Redhills Arterial Transport Network

Addendum to the 2020 Landscape and Visual Effects Assessment

March 2023

Version 0.3

Figure 4: NoR 1 After Design Change (Proposed North-south Arterial Corridor Alignment) Between Chainage 0-540 (Don Buck Road/Royal Road intersection) to just before Proposed Stream Crossing

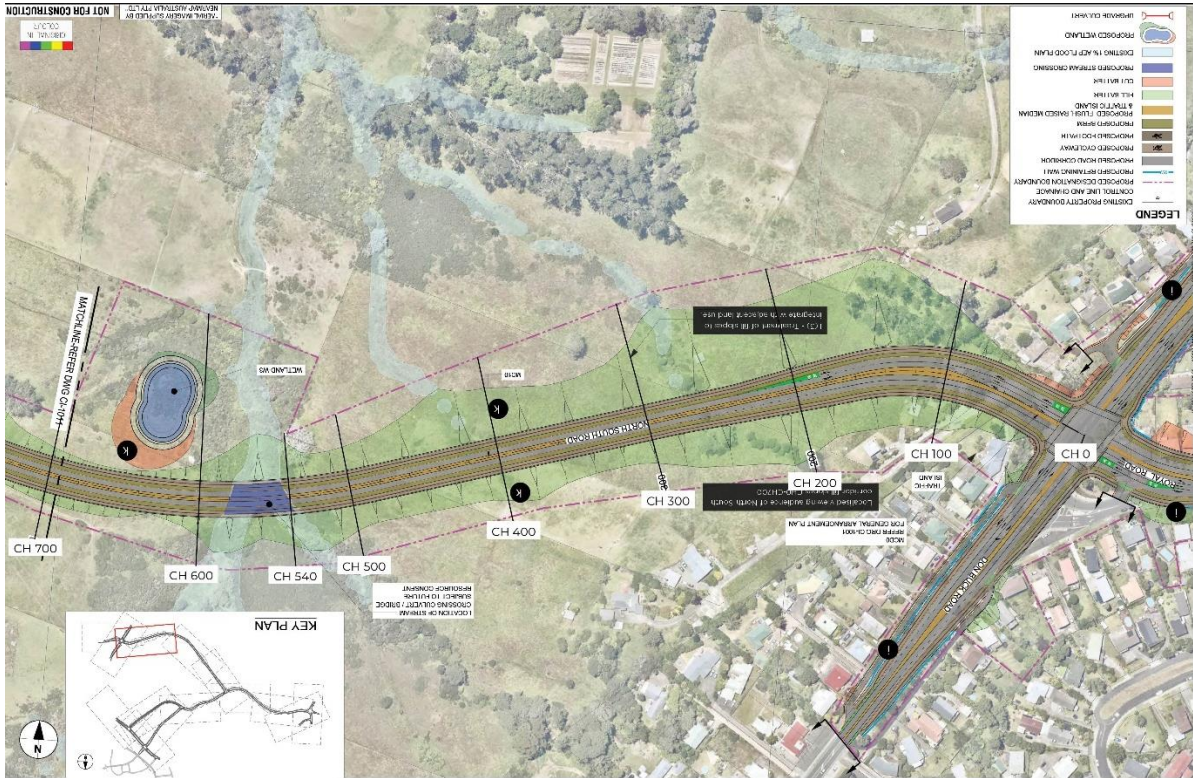
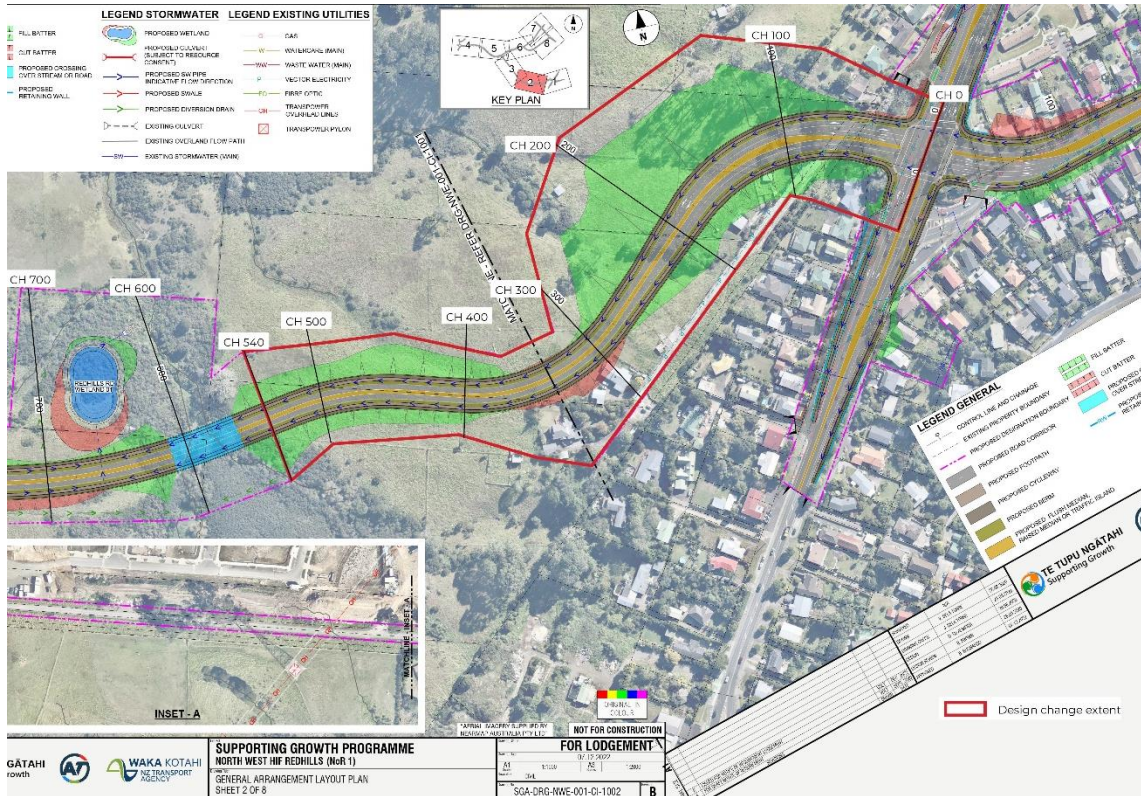
The design change alters the route between Don Buck Road/Royal Road intersection to just before the proposed stream crossing at CH 0-540. This change proposal is documented in the Redhills Resource Consent drawings SGA-DRG-NWE-001-CI-1001 and SGA-DRG-NWE-001-CI-1002 (refer Fig 4). Refer Appendix 1 for reference drawings relating to the RATN.

The alignment now bends southwest from CH 0-100 to run along the boundary with residential properties on Don Buck Road, before bending back to intersect with the original alignment at CH 0-540.

The route will be more elevated when compared with the original alignment and shifts further away from the tributaries of the Ngongetepara Stream. This achieves a key objective of minimising adverse effects on the biophysical values of the stream system, which contribute to the natural qualities of the landscape. It also means that this section of the RATN will sit closer to natural ground level thereby reducing earthworks volumes and helping to facilitate future local road connections. Overall, the new alignment will significantly reduce the amount of fill batter slopes and reduce modification to the natural landform.

The design change brings the designation closer to some residential properties on Don Buck Road when compared with the existing LVA extents. This will result in some dwellings being removed, while others will be in closer proximity to the new transport route alignment. The properties affected, and a description of the change is set out in Table 2 below.
